IN THE DRAWINGS:

REMARKS

ATTY DKT. No.: APPM/008348/MASK/MASK-ETCH/ARNOLD S
 U.S. SERIAL No.: 10/689,783 CONF. No.: 7569
 FILED: OCTOBER 21, 2003
 APPLICANT: APPLIED MATERIALS, INC.
 TITLE: MASK ETCH PROCESSING APPARATUS
 INVENTORS: NGUYEN, ET AL. PAGE 2 OF 11

FIG. 2

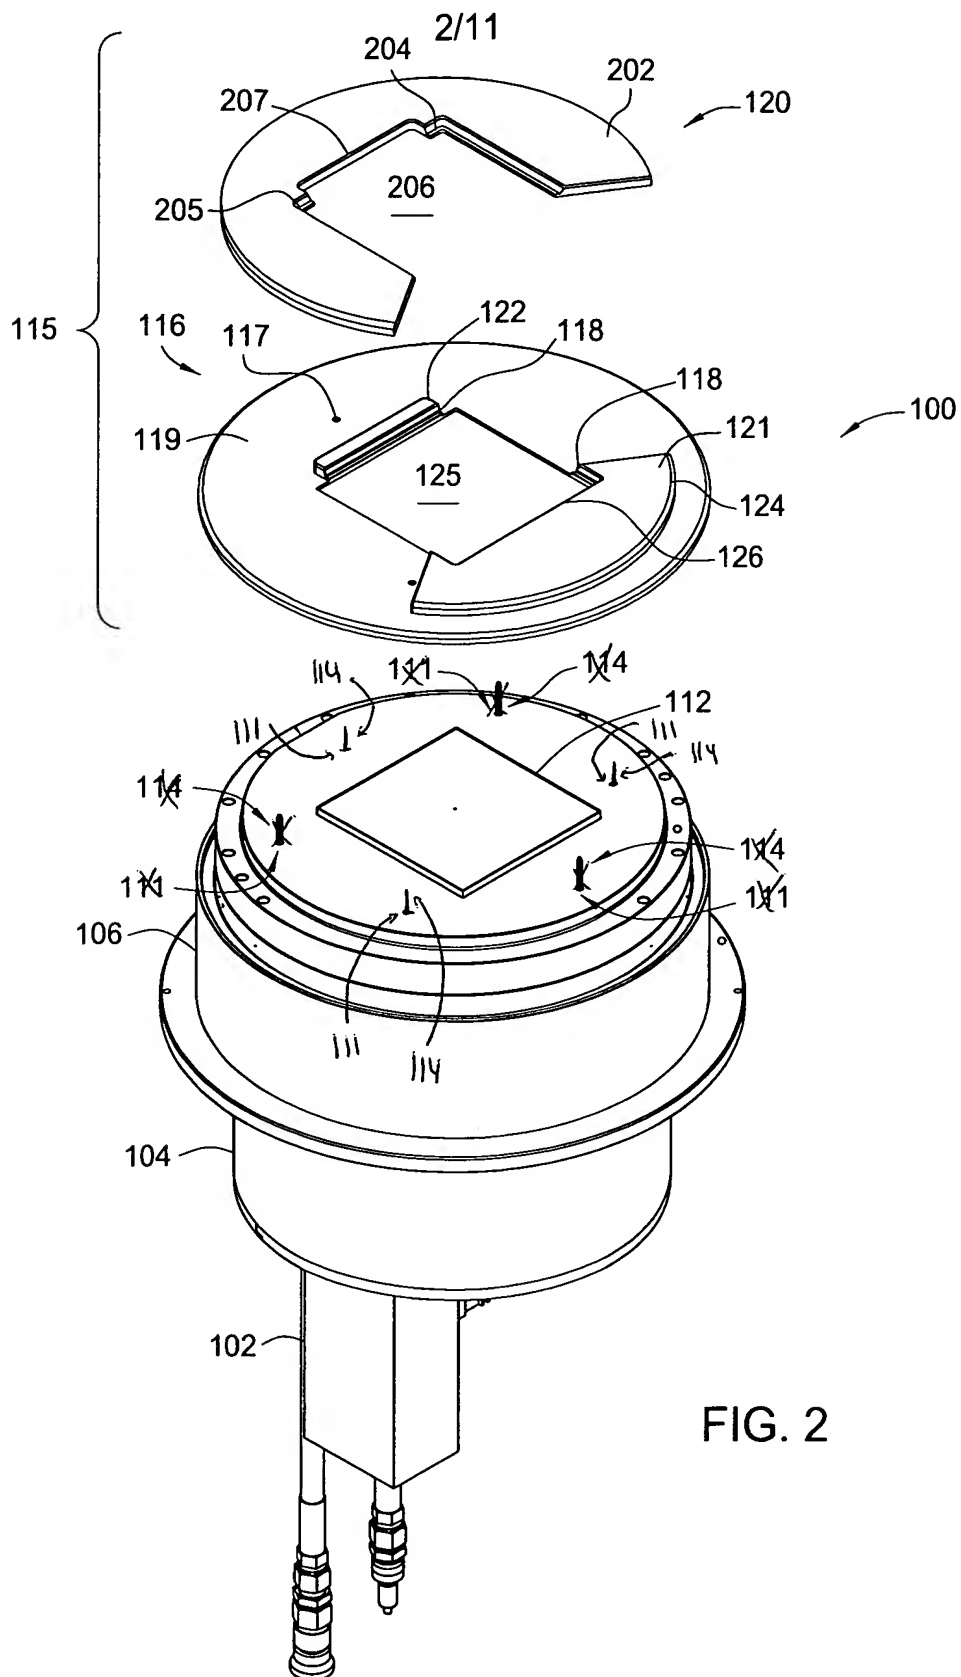
FIG. 2 has been amended. The channels 111 and lift pins 114 have been moved to be aligned with the channels 117. Support for the amendment is shown in Figs. 9-13.

FIG. 3

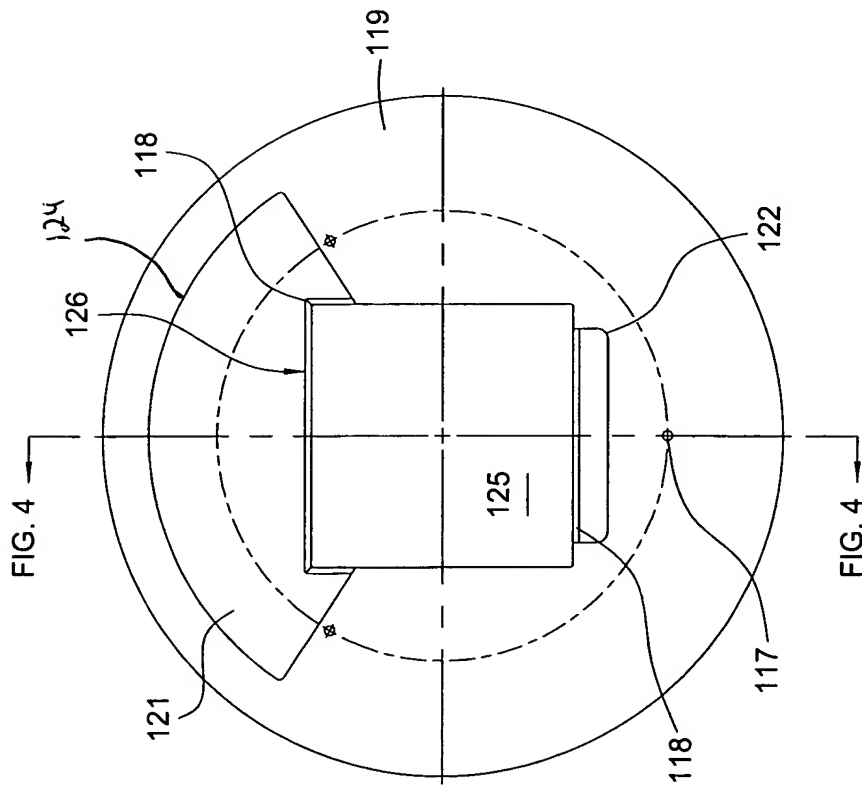
FIG. 3 has been amended. Previously omitted element 124 has been added.

FIG. 7

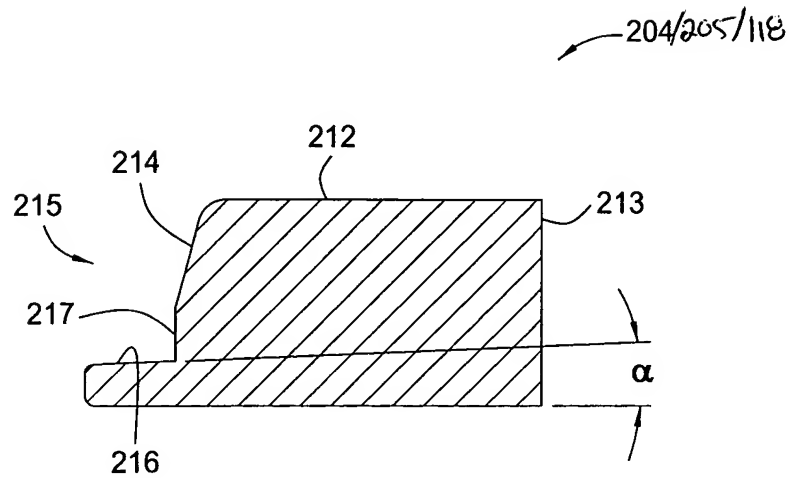
FIG. 7 has been amended. Previously omitted elements 205 and 118 have been added.

FIG. 14

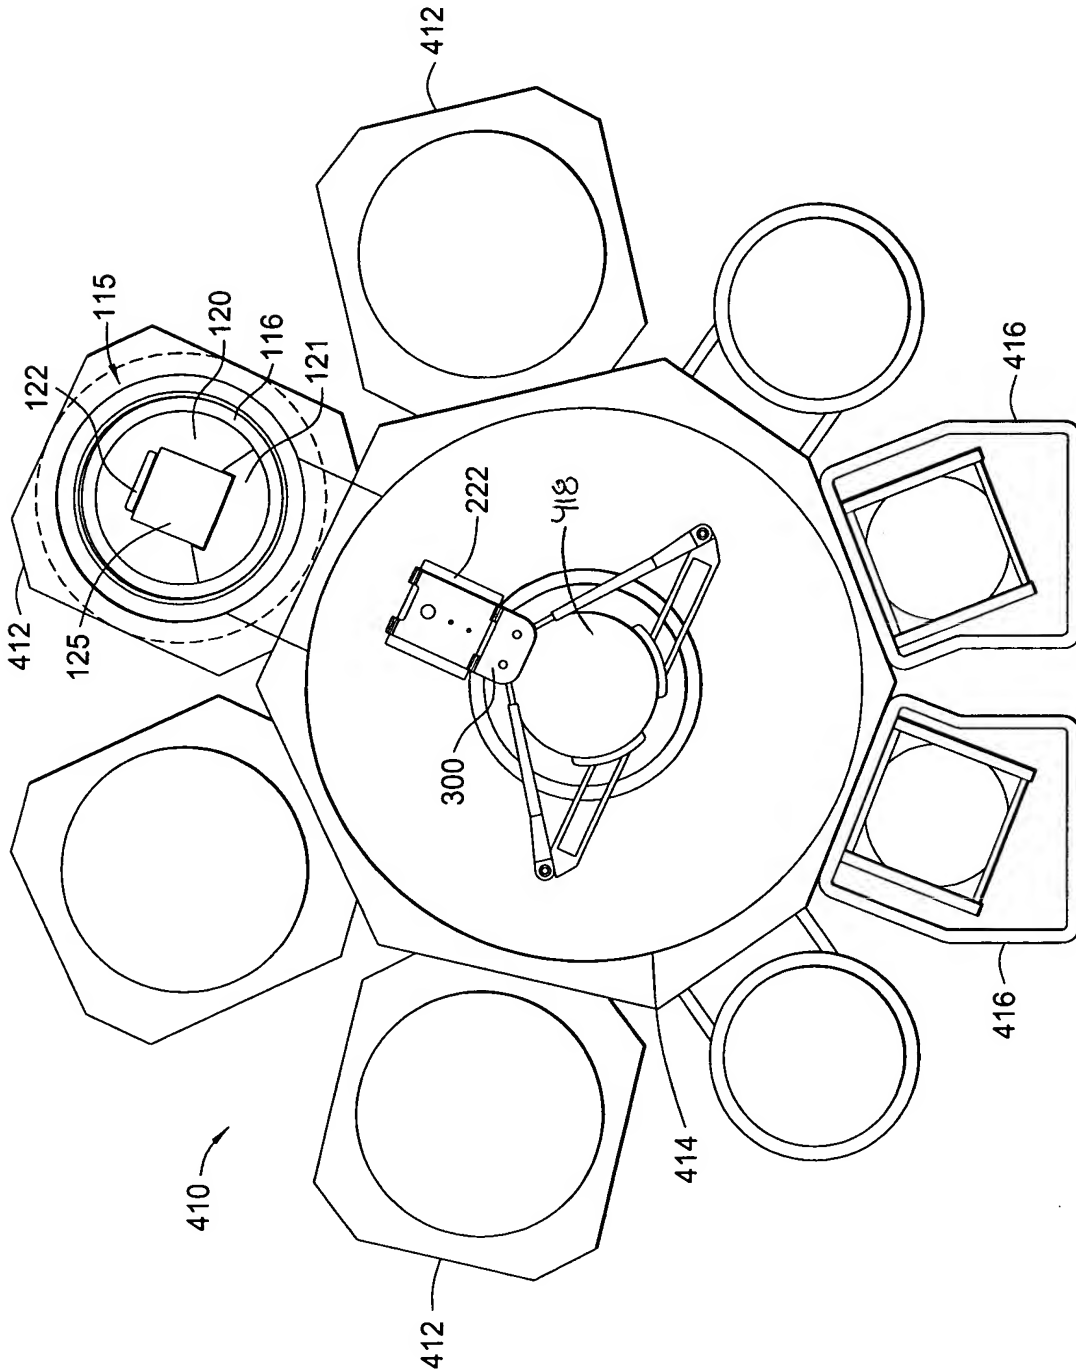
FIG. 14 has been amended. Previously omitted element 418 has been added.
